<b>McElroy Manufacturing, Inc.</b> The leader by design. Tulsa, Oklahoma U.S.A.		DRAWN: BEA	CHECK: MJA	APPR'D: RAD	DATE: 5/30/97	DWG No: 2402500	SHT No: 2	REV No: A	PART No:	2402502
	#824A ELECTRICAL SCHEMATIC 380-415V, 50Hz, 3Ph

**DESCRIPTION:** #824A ELECTRICAL SCHEMATIC 380-415V, 50Hz, 3Ph

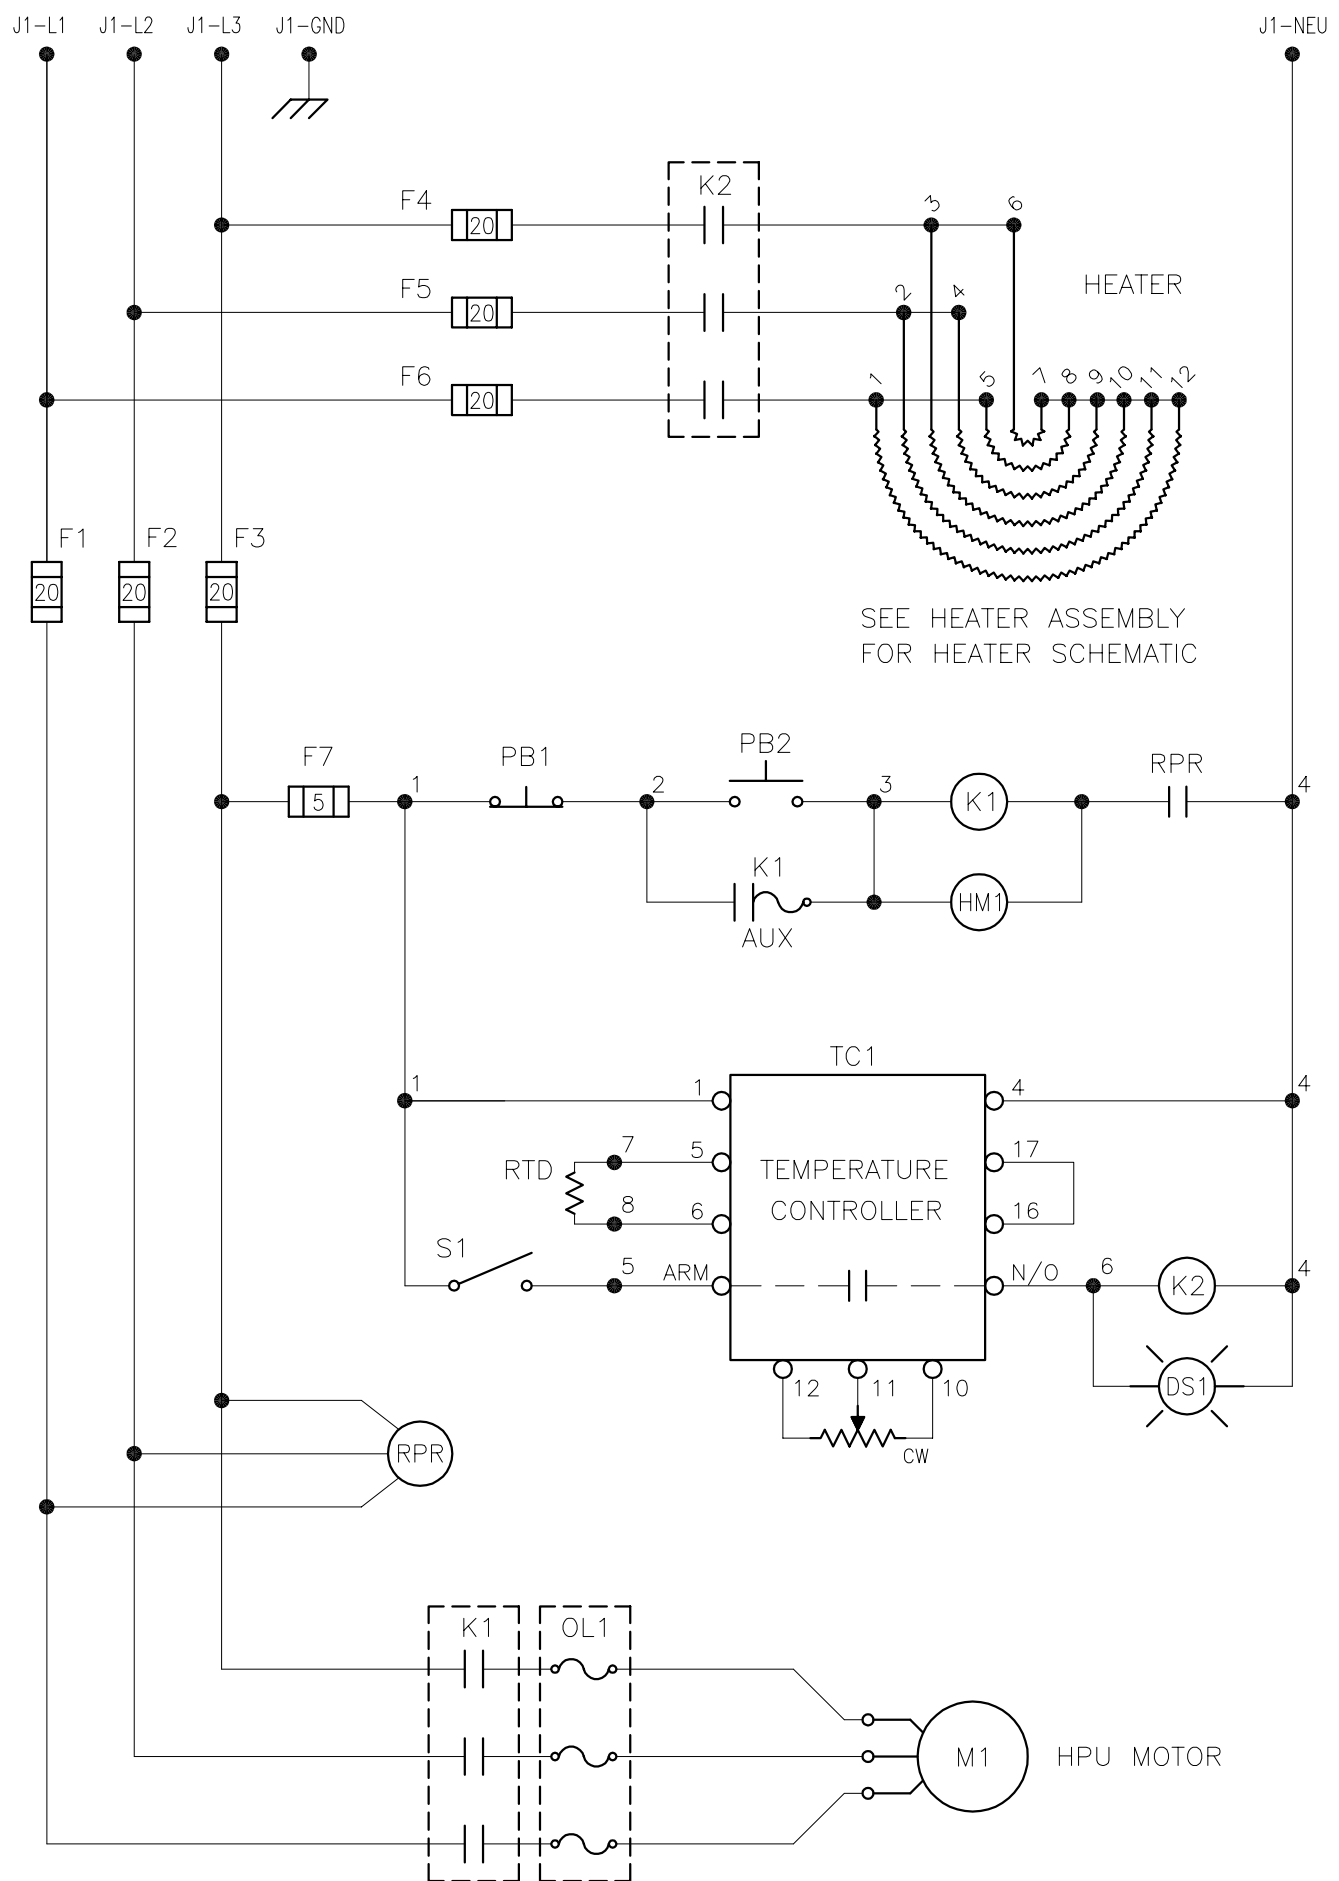
<u>APPR.</u>	<u>REV</u>	<u>DATE</u>	<u>BY</u>	<u>DESCRIPTION OF REVISION</u>
JRP	A	04/17/06	BEA	TO MAKE COMPATIBLE WITH 380VOLT SUPPLY: ADDED SEPARATE OVERLOAD UNIT (OL1). ADDED NOTE ON FACE OF DRAWING TO ADJUST OVERLOAD TO 125% OF MOTOR NAMEPLATE FLA. CHANGED TITLE TO INCLUDE 380 VOLT POWER.

ADJUST OVERLOAD TO 125% OF MOTOR NAMEPLATE FLA.
